APPLICATION NO.	FILING DATE	FIRST NAMED INVENTOR	ATTORNEY DOCKET NO.	CONFIRMATION NO.
10/525,251	08/05/2005	Richard Perrin	M0025.0319/P319	3630
24998 7590 12/14/2007 DICKSTEIN SHAPIRO LLP 1825 EYE STREET NW Washington, DC 20006-5403			EXAMINER KOSANOVIC, HELENA	
			ART UNIT 3749	PAPER NUMBER
			MAIL DATE 12/14/2007	DELIVERY MODE PAPER

Office Action Summary	Application No.	Applicant(s)	
	10/525,251	PERRIN, RICHARD	
	Examiner	Art Unit	
	Helena Kosanovic	3749

DETAILED ACTION

(fig. 3, of Magill)

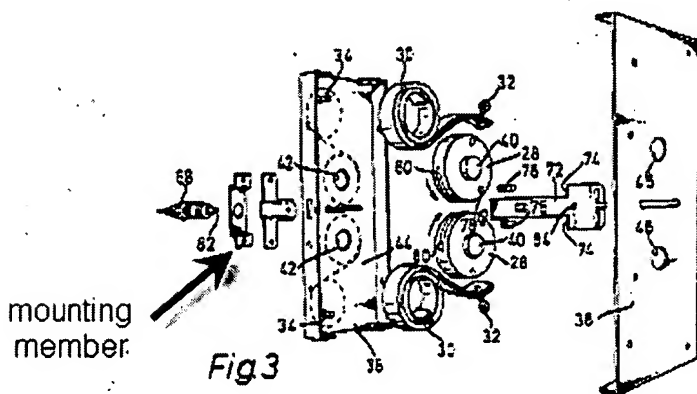
Regarding claim 47, the body member comprises a cylindrical casing (86) mounted by a holder (fig. 3, see paragraph below where the examiner labeled originally not labeled element with darkened arrow), said opening in the exterior of the body member being in the holder.

Regarding claim 52, the casing has a recess (see paragraph below where the examiner labeled originally not labeled elements for clarification with darkened arrows), the movable member is within the casing (figs. 9-11), and the head has a detent (triangle part of element 70) engaging in the recess such that when the heat-softenable or meltable material is soft or molten, a force on the head in a direction of its movement with respect to the casing would cam the detent out of the recess in a direction generally at right angles to the direction of movement of the head and release the head, thereby causing the movable member to move, the heat-softenable or meltable material being between the detent and the casing and being such that said force applies a force on the heat-softenable or meltable material generally at right angles to the direction of movement of the head.

3. The examiner labeled originally not labeled elements for clarification:

(fig. 9 of Magill)

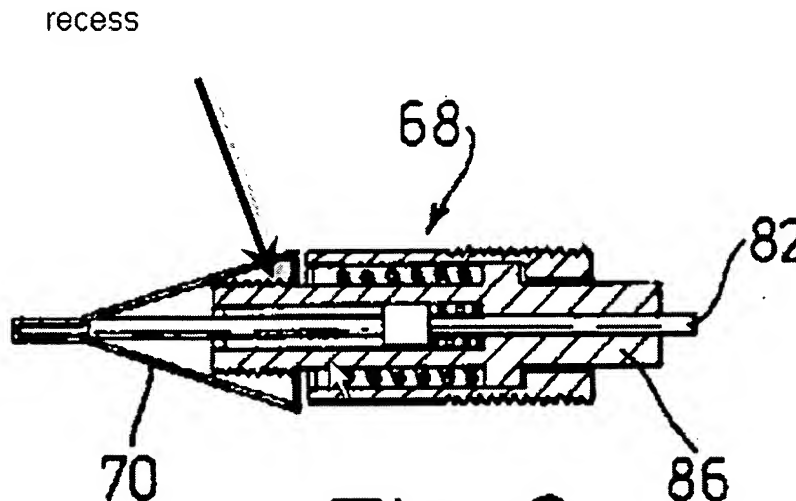
Regarding claim 48, body member 68 is extended, the temperature-sensitive element being adjacent one end of the body member and the opening in the exterior of the body member being adjacent the other end of the body member (fig. 9).

Regarding claim 54, the head comprises an end piece (end on the right-hand part of element 70) which is adjacent or abuts the end of the movable member (fig. 9), the end piece having elongate detents (left side of the triangle 70) which extend outside the casing and parallel to the movable member (figs. 9-11).
